Tompkins County ADA Transition Plan - 2017

Project: Tompkins County Transition Plan 2017

Building: Recycling and Material Management Office Building (former Solid Waste)

Date: April 28, 2017

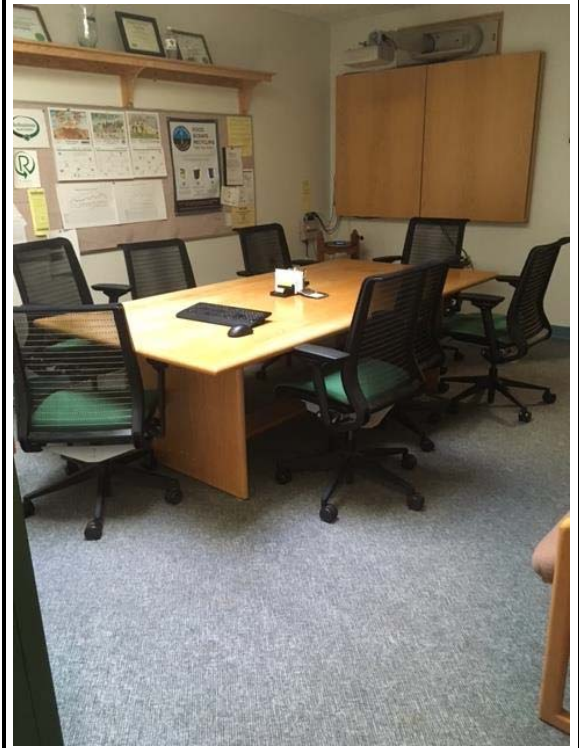
2.36	Is the threshold no more than ¾ inch high with the top ½ inch beveled no steeper than 1:2, [404.2.5, 303.2]	No	No threshold – carpet.
2.37	Is the door equipped with hardware that is operable with one hand and does not require tight grasping, pinching or twisting of the wrist? Door handle?	Yes Yes	 <p style="text-align: center;">Door pictured is a toilet room.</p>

Priority 3 - Toilet Rooms

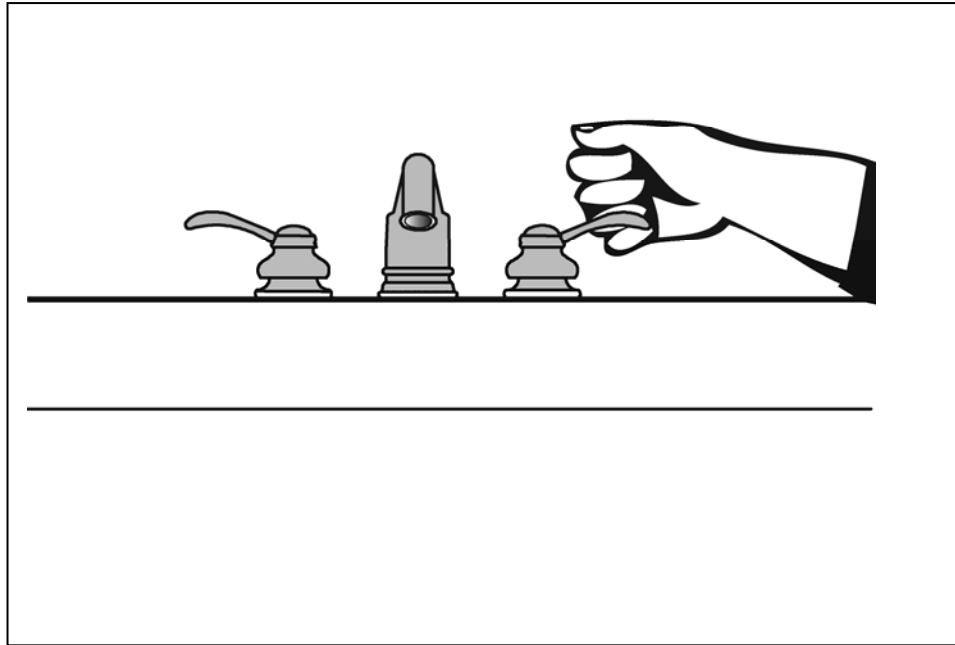
3.16	If the mirror is over a lavatory or countertop, is the bottom edge of the reflecting surface no higher than 40 inches above the floor? surface no higher than 35 inches above the floor?*[603.3]	No Measurement: 43"

3.17	If there is a coat hook, is it no less than 15 inches and no greater than 48 inches above the floor?*[603.4]	No Measurement: 64"	Provide additional accessible coat hook in unisex toilet room.

Item	Correction	Target Date	Date Completed
3.17	Provide additional coat hook in two toilet rooms.	August 2017
